Planning Commission  
Radnor Township  
Wayne, Delaware County, Pennsylvania

1. 13-D-09 – Enrico Partners LP - Amended Final Land Development - 771-797 East Lancaster Avenue to construct a commercial retail, office and restaurant building – Submitted 8/26/13

# "VILLANOVA CENTER" AMENDED FINAL LAND DEVELOPMENT PLANS

Gannett Fleming, Inc. has completed our preliminary review of the Final/Revised Plan for Villanova Center for compliance with the Radnor Township Code. These plans are a revision to a previously approved land development plan. The previous approval is in accordance with an Order of the Court of Common Pleas of Delaware County dated October 1, 2003 approving the Settlement and Stipulation Agreement dated March 25, 2003 pertaining to the development of the subject property.

**POST DEVELOPMENT DRAINAGE AREA PLAN**

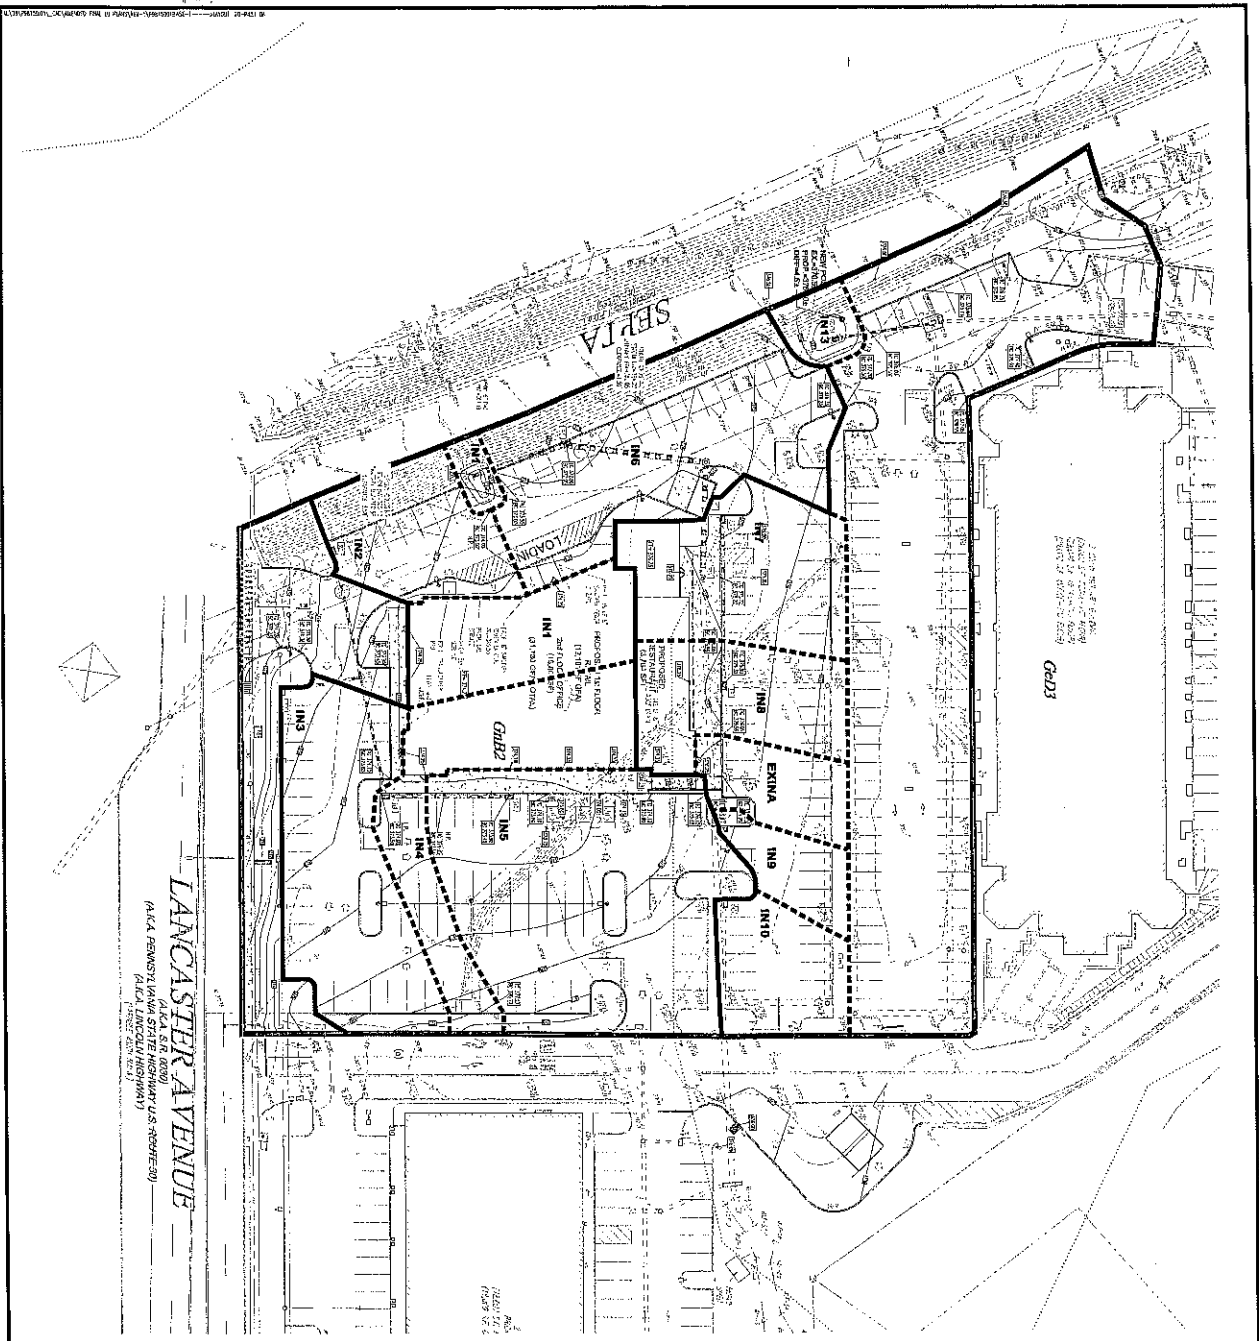
3. Two separate sanitary sewer laterals must be provided for the proposed restaurant and a grease interceptor provided on one of the laterals. The laterals should be configured as such that domestic sewage is not routed through the grease interceptor.
4. Sewage Facilities Planning must be addressed for the increase in wastewater discharge.
5. §206-3(A) – Traffic and parking control standards – Fire lanes, at least 10 feet wide, shall establish and maintained in the parking area and the front, side and rear of the buildings and structures on subject premises and shall be properly painted and marked as such.
6. The new remote banking area is not shown in the post development drainage plan.

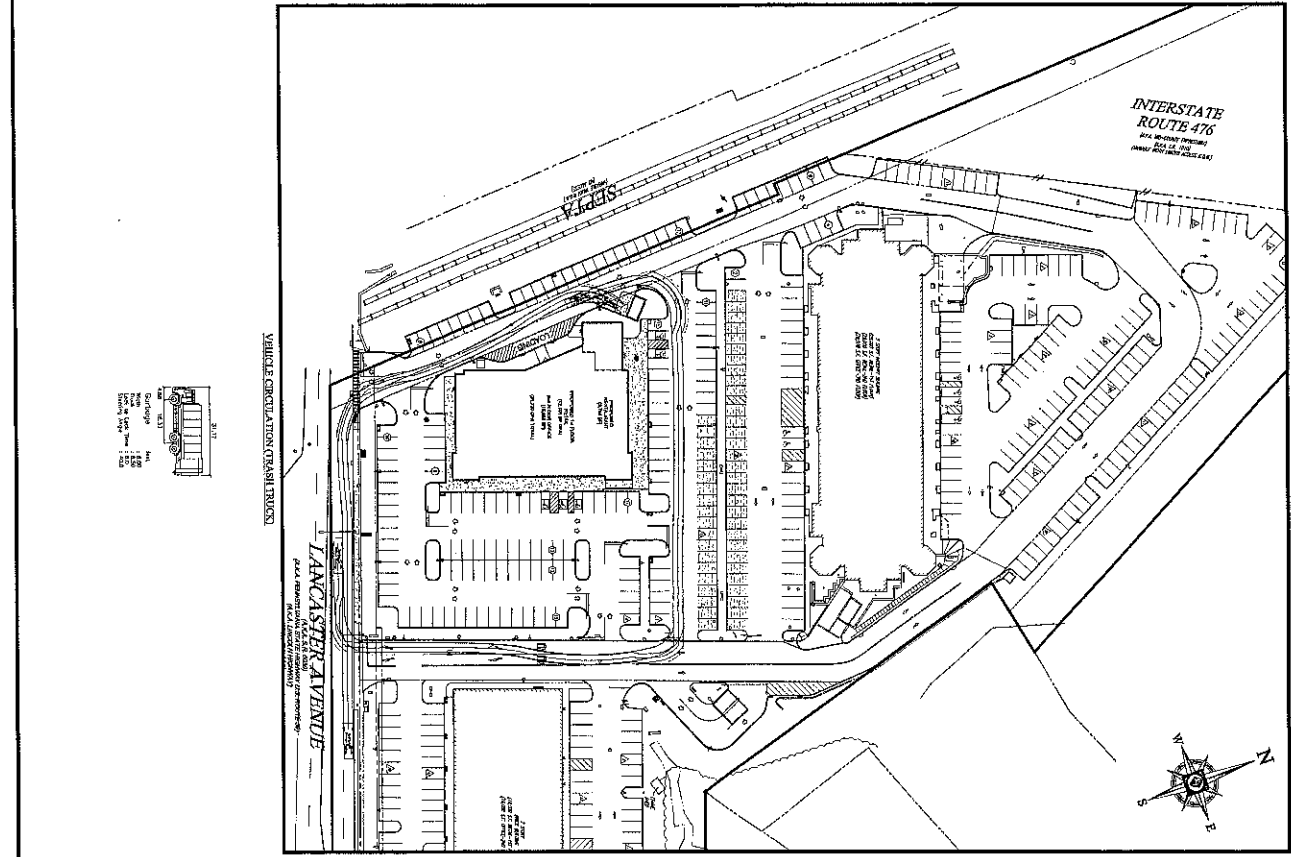
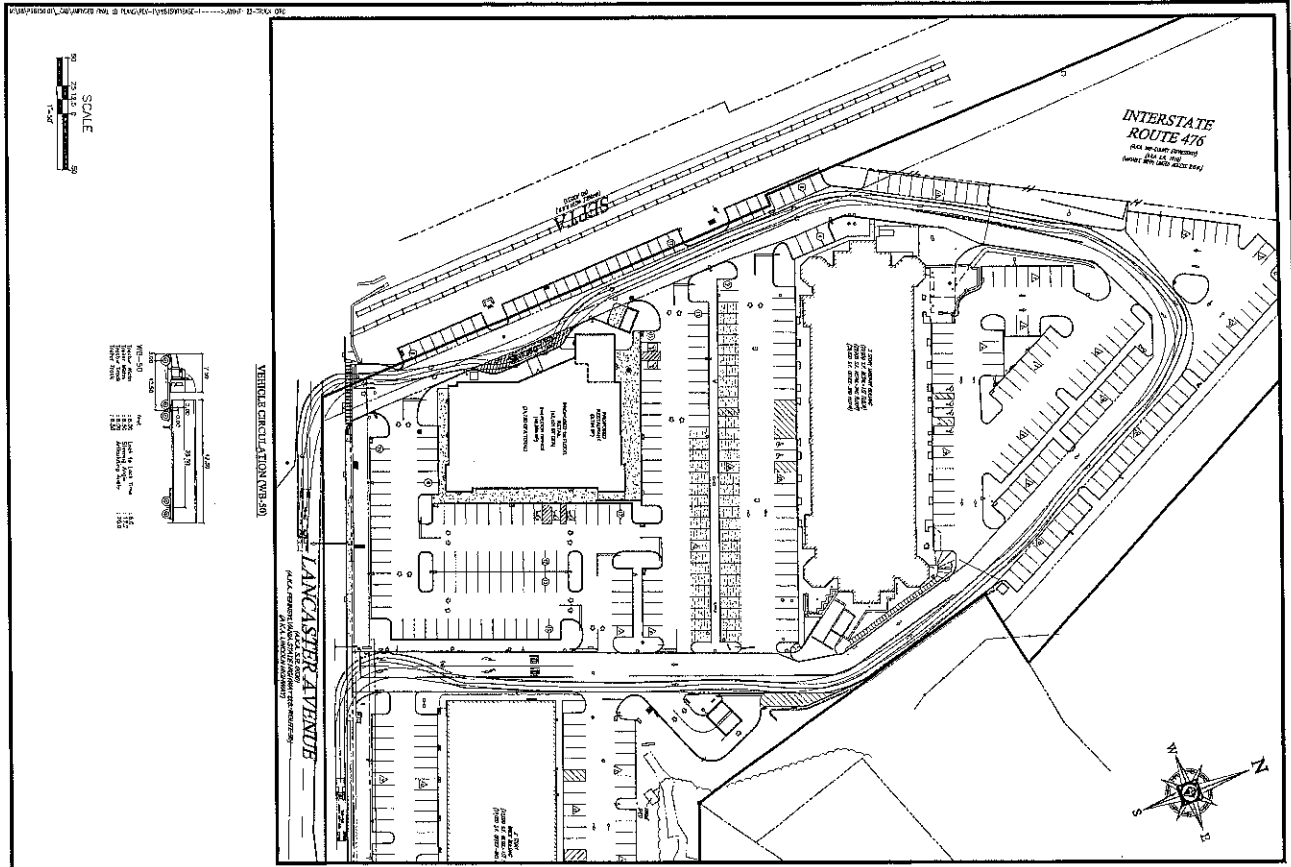
3. In accordance with the September 3, 2013 coordination meeting with PennDOT, the western-most driveway should be designed as a right-in/right-out. Provide appropriate pavement markings and signing to indicate the restrictions. Update the site plan and truck turn analysis plan accordingly.

5. It is likely that trucks will enter the western-most driveway to access the loading area and then continue through the site to exit at the signalized driveway. Therefore, update the plan to show the truck circulation for that movement to verify that trucks can move internally within the site.

6. The circulation plan for the WB-50 shows major encroachment on the egress lanes at the signalized access. Determine whether there will be time of day restrictions on deliveries to avoid conflicts with other vehicles. If not, consideration should be given to restricting westbound truck access at this driveway and relocating the truck traffic to the driveway to the west, as it appears that trucks may have improved maneuverability due to the angle of the driveway.

7. Update the truck turn analysis plan to show the circulation of trucks for all allowed movements (i.e., eastbound left at the signalized intersection, etc.).
